**Maine Maritime Academy
Castine, Maine**

**Pier Upgrades and Waterfront Improvements Project
April 10, 2024
ADDENDUM NO. 12**

Questions submitted on S-116 (snippet below).

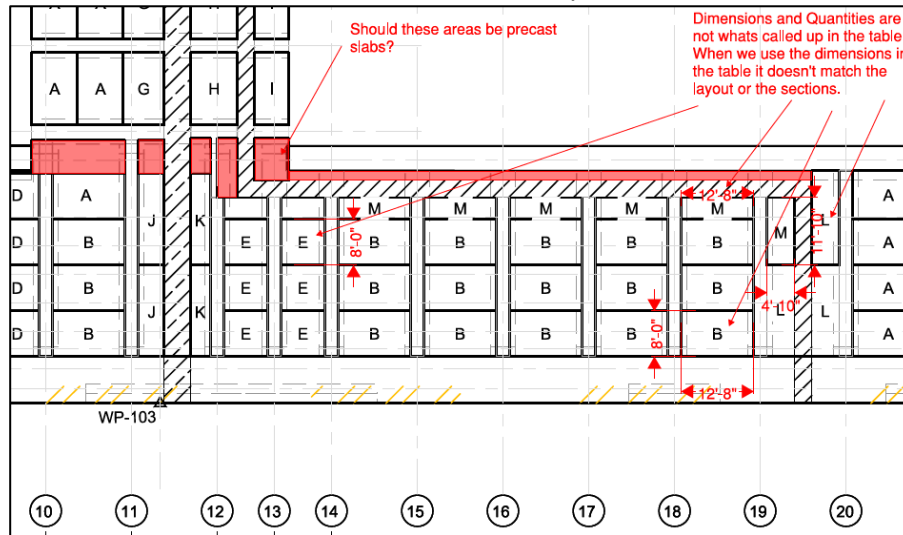
11. IFB Drawing S-116: Please see attached detail sheets with questions on precast details. Please clarify details.

1. Should these areas be precast slabs?
2. Dimensions and Quantities are not what's called up in the table. When we use the dimensions in the table, it doesn't match the layout or the sections.

Response 11: See IFB Drawing S-116 issued under Addendum 7.

Questions submitted on S-116 (snippet below).

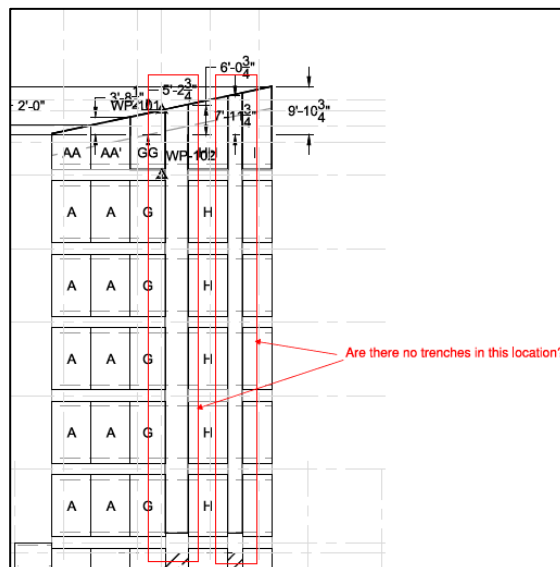
12. IFB Drawing S-116: Please see attached detail sheets with questions on trench details. Please clarify details.

3. Are there no trenches in this location?

Response 12: See IFB Drawing S-116 issued under Addendum 7.

Questions submitted on S-116 (snippet below).

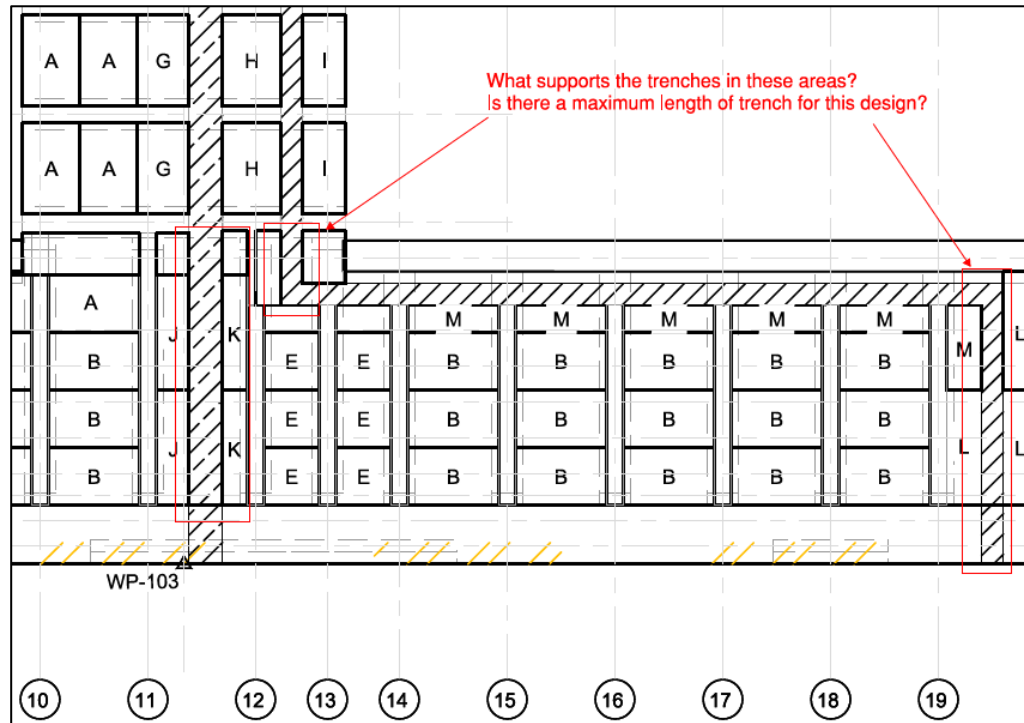
13. IFB Drawing S-116: Please see attached detail sheets with questions on trench details. Please clarify details.

1. What supports the trenches in these areas?
2. Is there a maximum length of trench for this design?

Response 13: Between Bents 11 and 12 and between 19 and 20, there is a cast-in-place slab and trench walls. See IFB Drawings S-126, S-129 and S-151 issued under Addendum 11.

See IFB Drawings S-126 and S-140 issued under Addendum 11 for the support at the 90 degree bend in the trench between Bents 12 and 13.

See Addendum 10, Response 10 for the maximum length of trench of sections.

North Edge Beam Detailing, Bent 10 to Bent 13 (For Bidding Purposes)

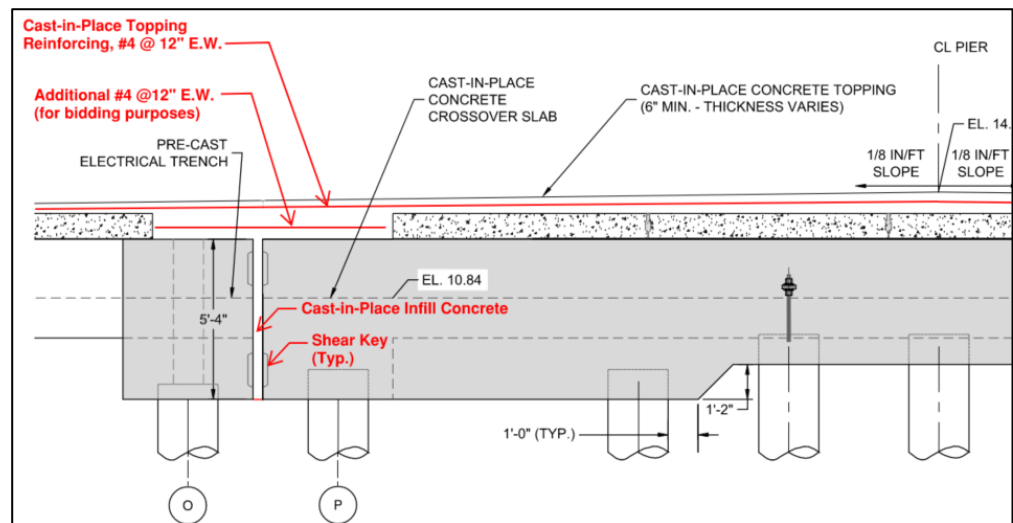
17. IFB Drawing S-130: Please provide Section K for the North Edge Beam on Drawing S-130.

Response 17: From Bent 10 to Bent 13, except at the mechanical trench and electrical trench, the spacing between the North Edge Beam and the north end of the pile caps shall have cast-in-place concrete infill with shear keys in the North Edge Beam and pile caps. Provide an additional lower level of reinforcing steel, #4 at 12" each way, in the deeper cast-in-place concrete topping. See sketch below for bidding purposes.

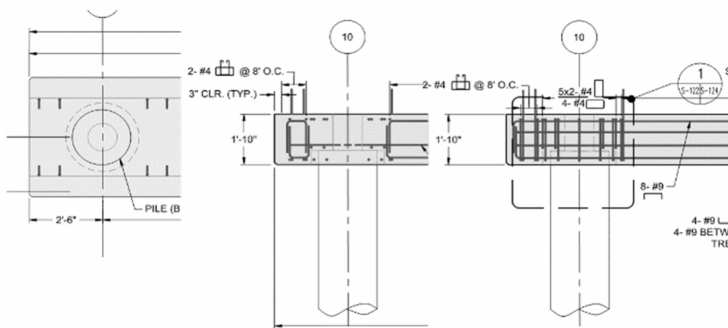
21. IFB Drawing S-135 - S-139: 1. The Precast Pier Pile Cap Details show light colored and dotted lines in section view projecting above the pile and beside the pile. A note in the plan view indicates a "Pile Blockout and Grout Hole (TYP.)". Please confirm this is a bond-out in the precast pile cap. 2. Please clarify the intent of the bondout, further the pile plans call for a concrete plug, if this bondout is for the purposes of placing material in the pile, please clarify whether the material placed in the pier pile is required to be grout or concrete. 3. The pile bondout which seems to be indicated on the drawings, appears to be partial depth with an annular space around the pile extending to the bottom of the pile cap. Please confirm this is the intent of the drawing. If this is the intent, will grout tubes be permitted to be cast into the precast pile cap to permit grouting of the annular space after the pile cap has been installed on the pile. Please see the screen shot below for reference.

Response 21: The precast pile caps have a blockout (bondout) to facilitate grout placement for the pile cap connection. See IFB Drawing S-132 issued under Addendum 11.
